**TOWN OF NEWBURGH
PLANNING BOARD
TECHNICAL REVIEW COMMENTS**

PROJECT: GARDNERTOWN COMMONS
PROJECT NO.: 2016-03
PROJECT LOCATION: SECTION 75, BLOCK 1, LOT 21
REVIEW DATE: 28 APRIL 2017
MEETING DATE: 4 MAY 2017
PROJECT REPRESENTATIVE: JCM PLANNING ENGINEERING

RE: JMC Project 15155
 Gardnertown Commons
 Gardnertown Road
 Town of Newburgh, NY

SP-11

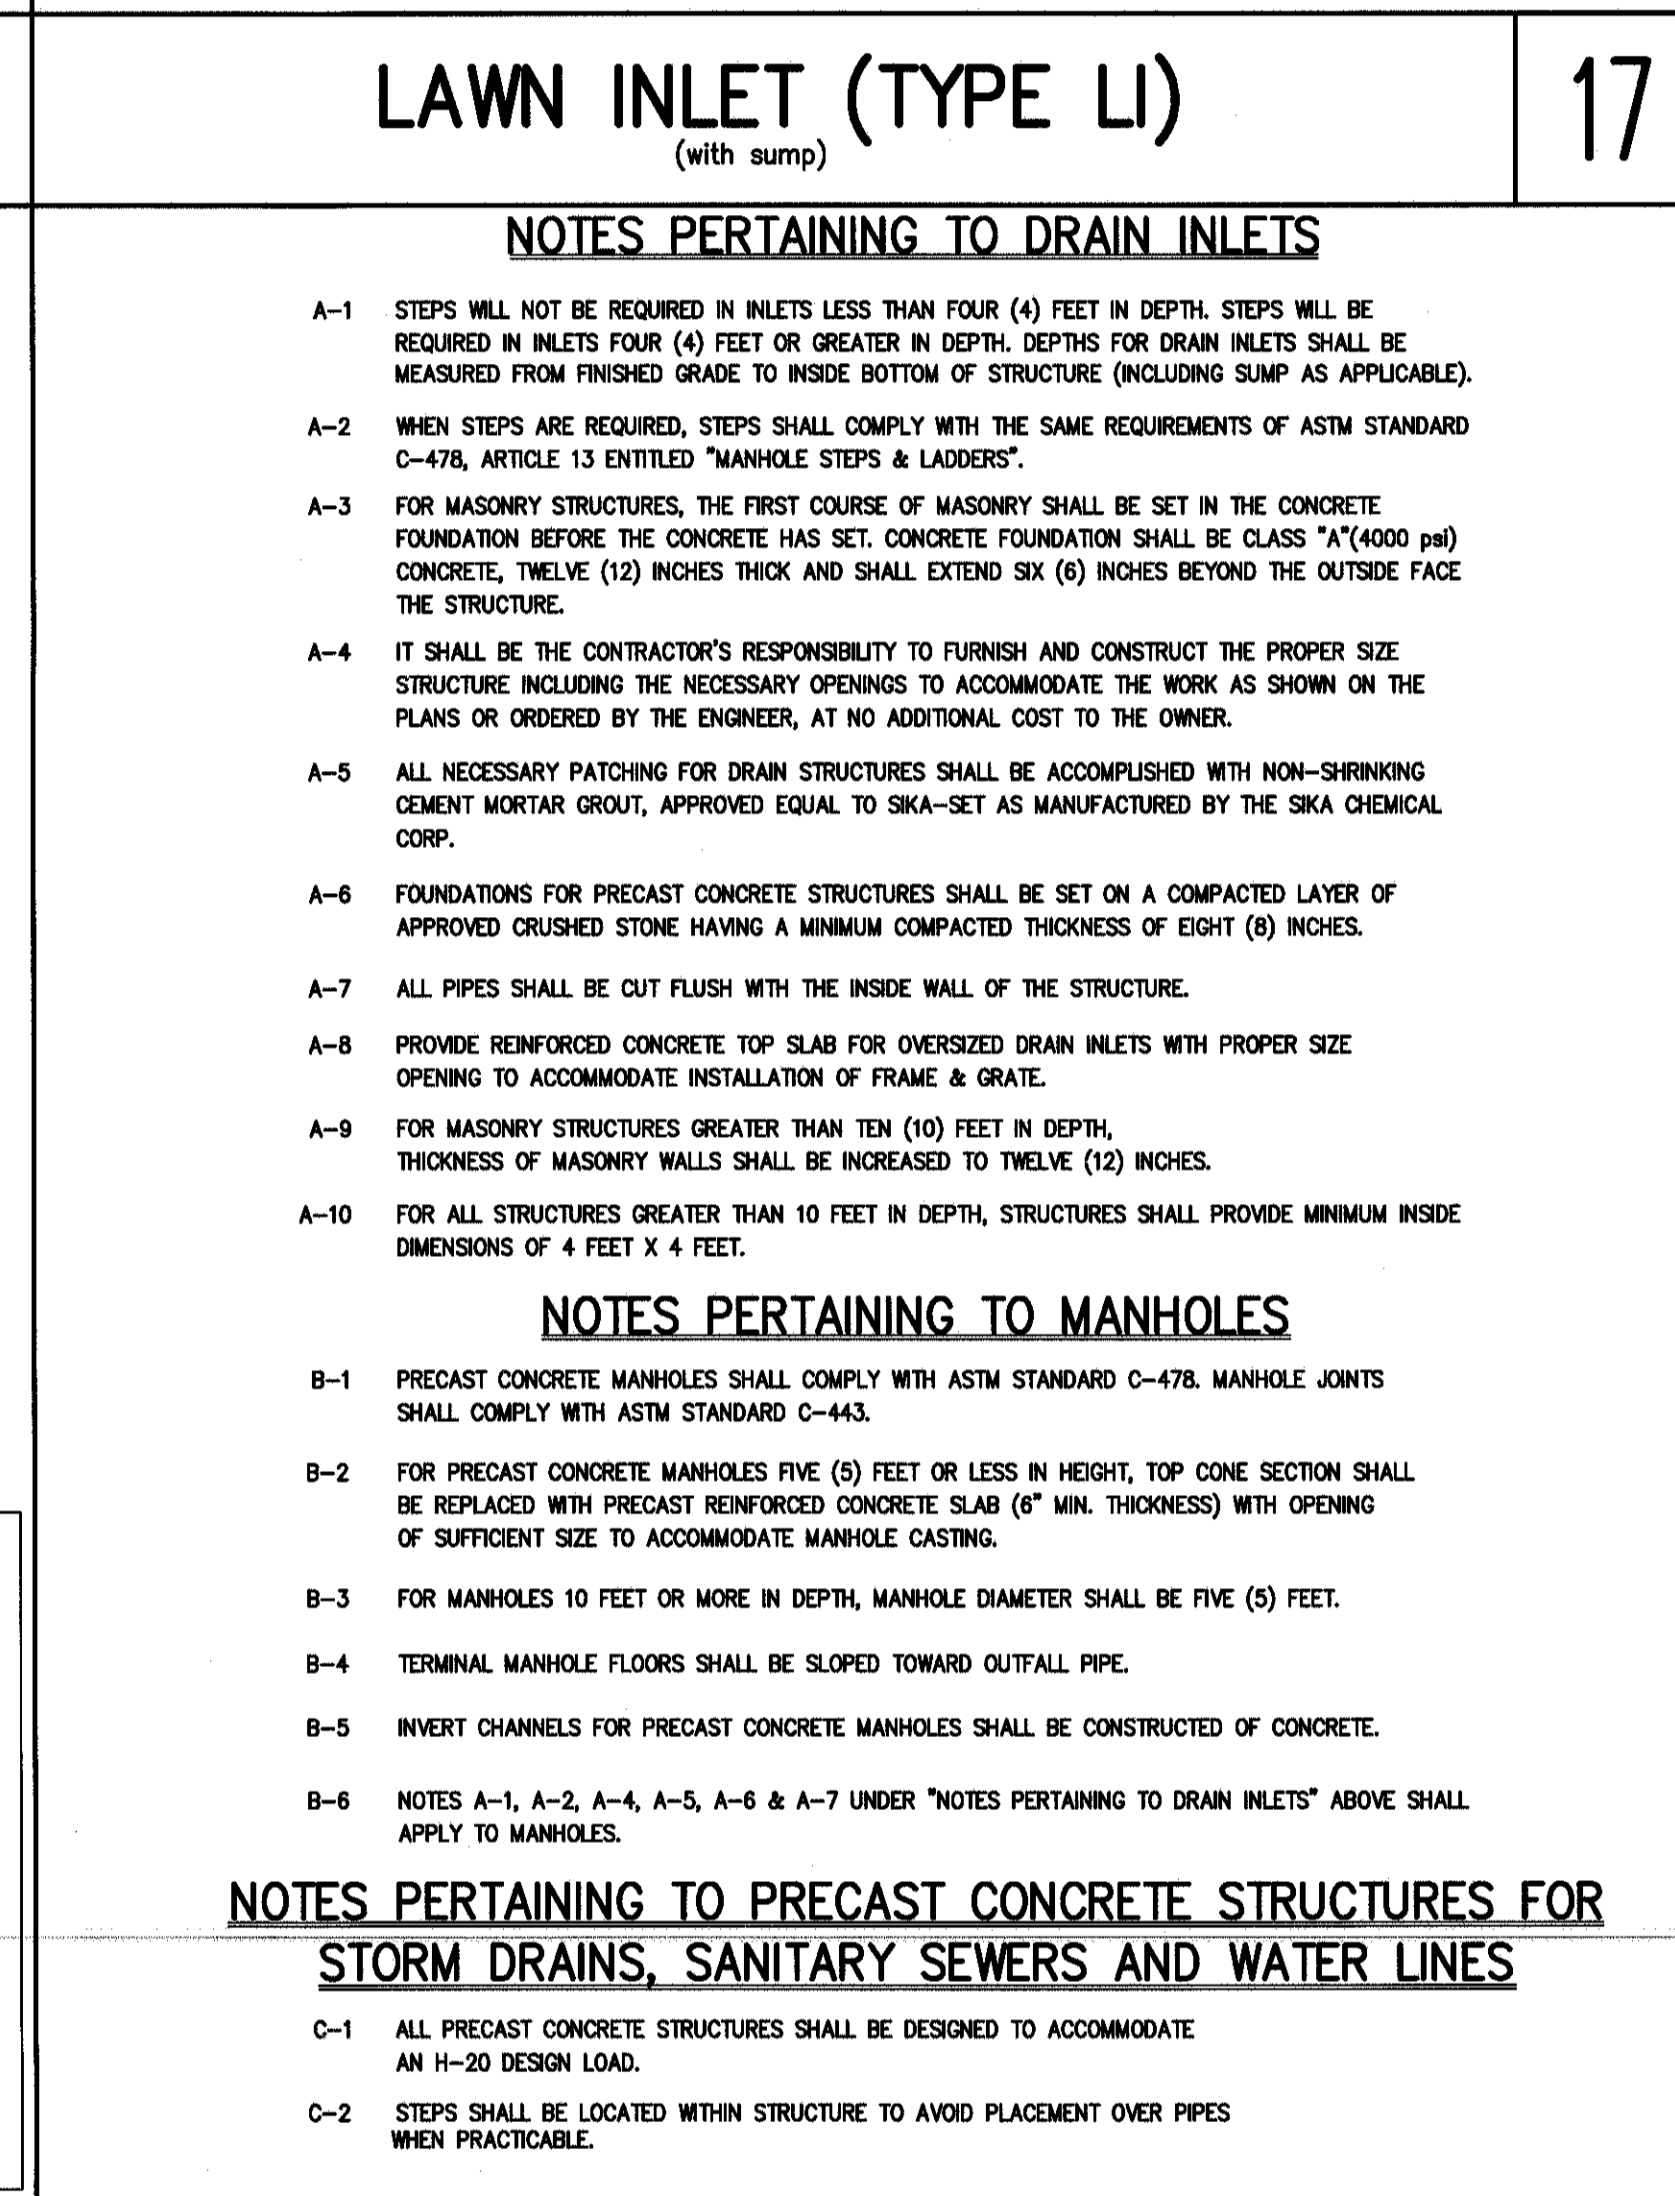
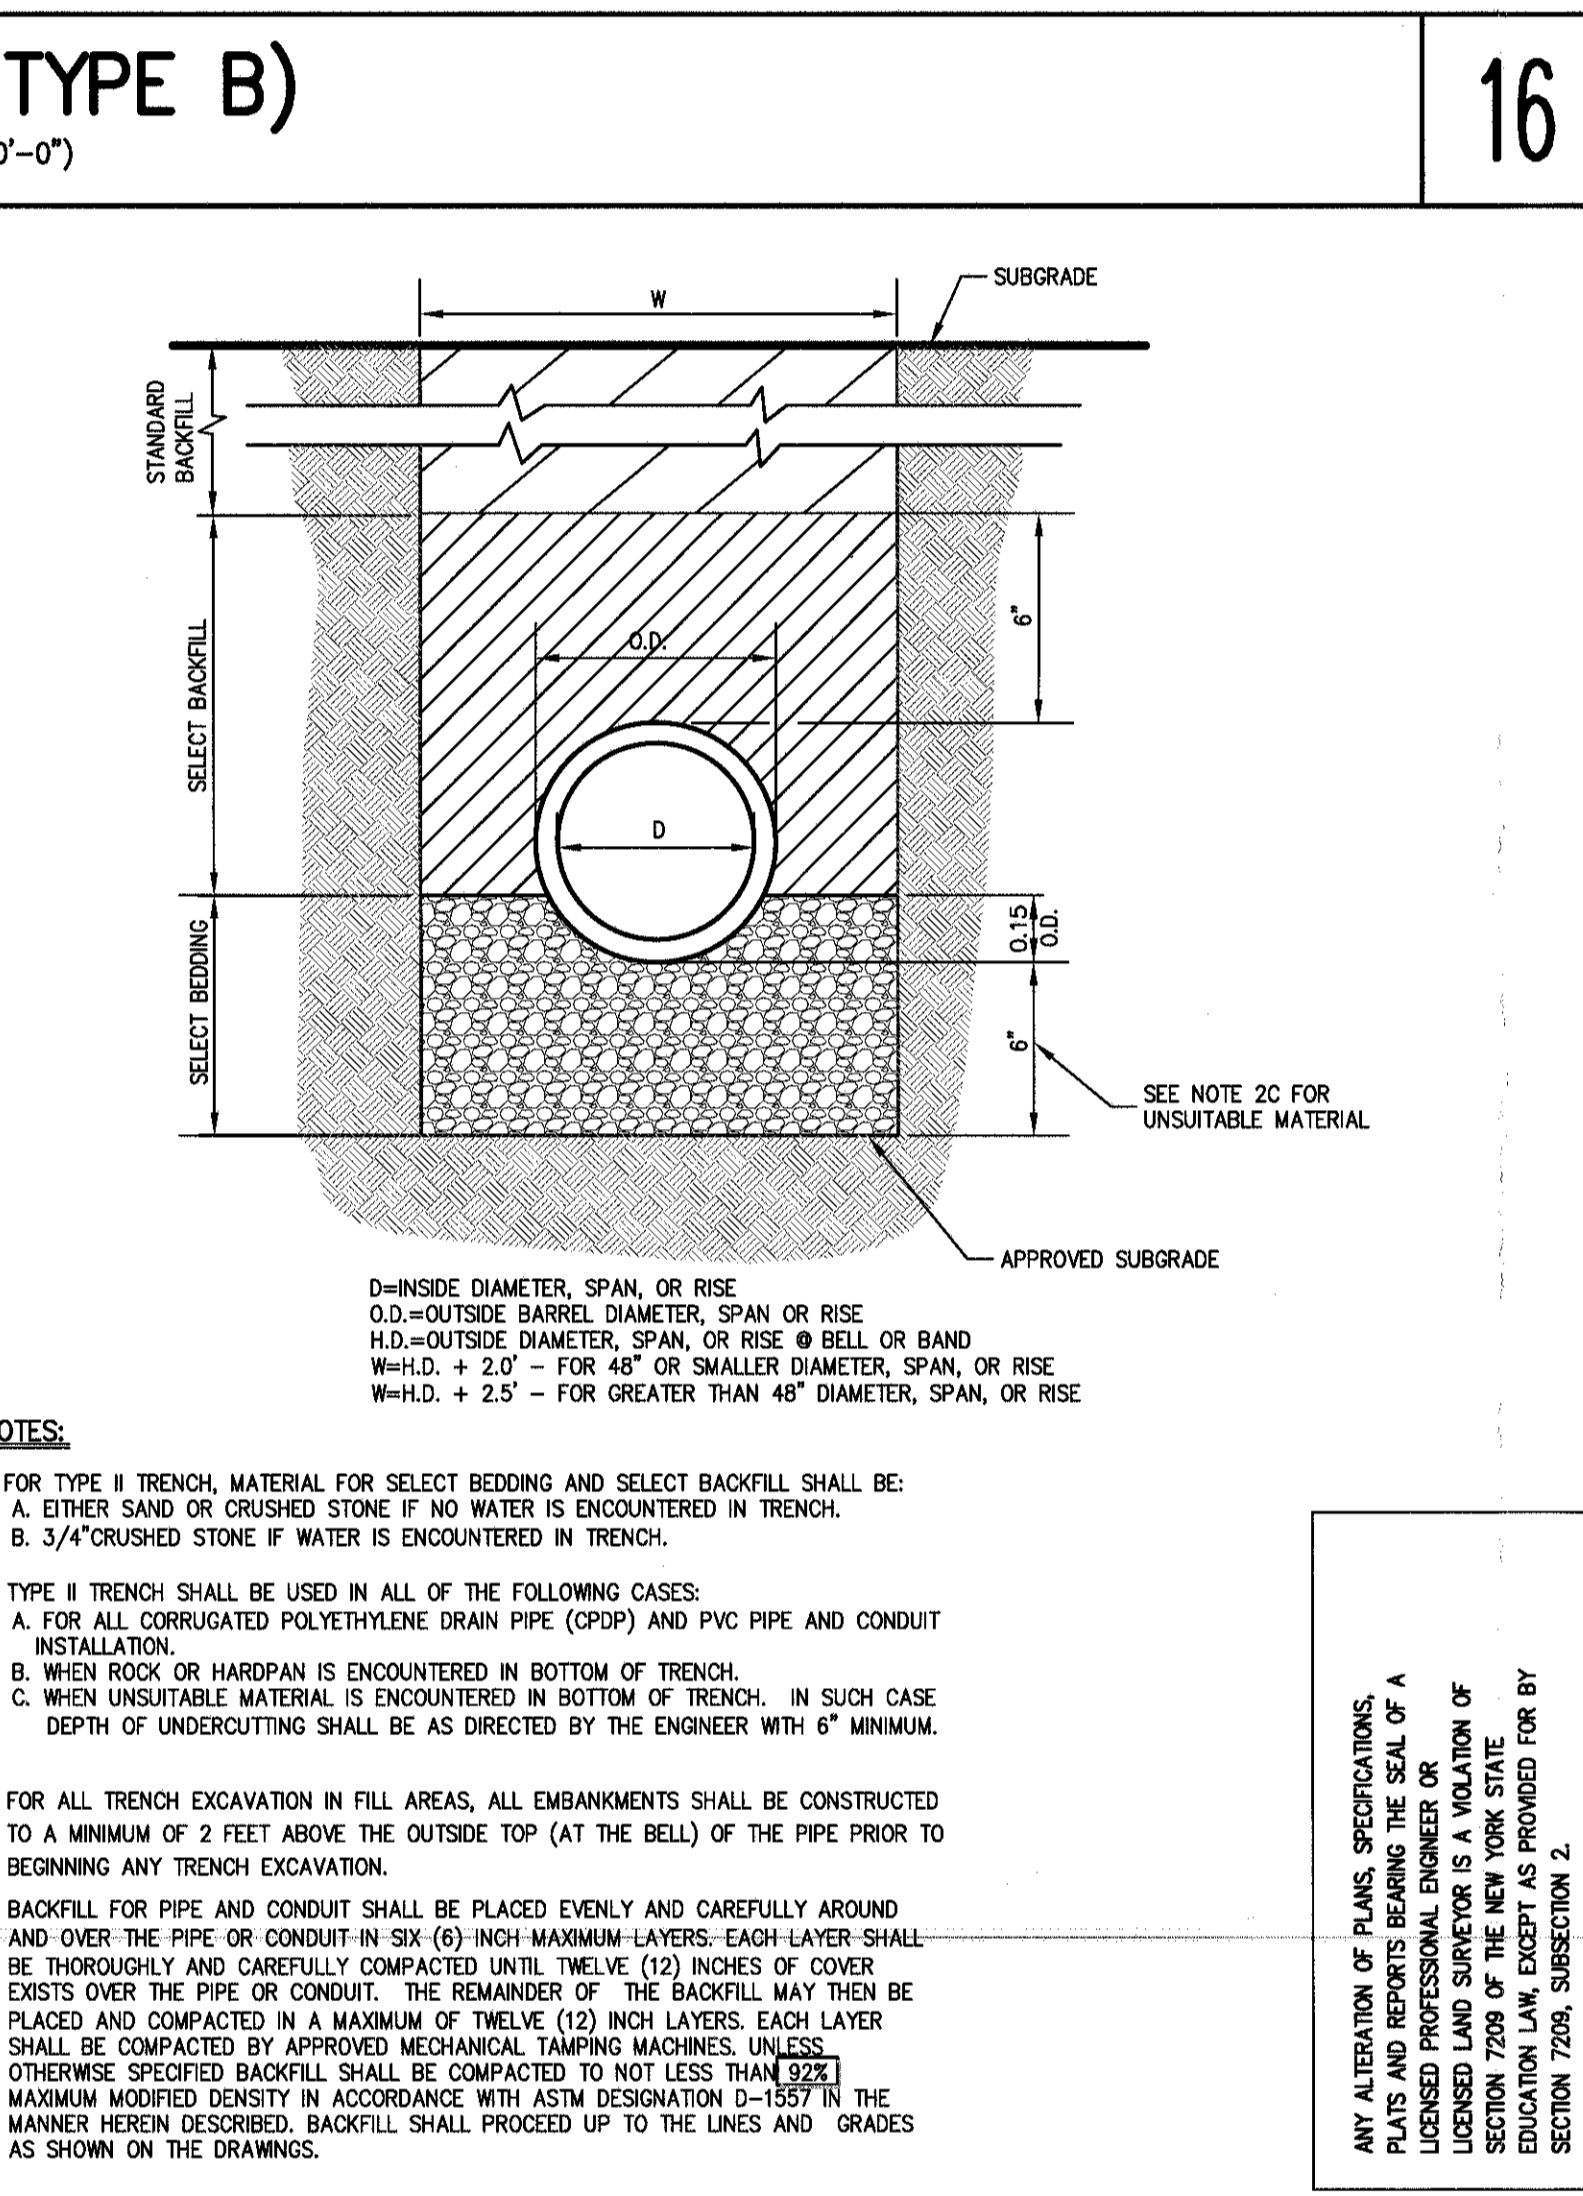
- j. *Anti vortex riser detail references a table for sizing of the devices. Location of this table should be noted.*

Detail #3 on Sheet SP-11 now has a table listing the sizing of the temporary riser & anti-vortex devices.
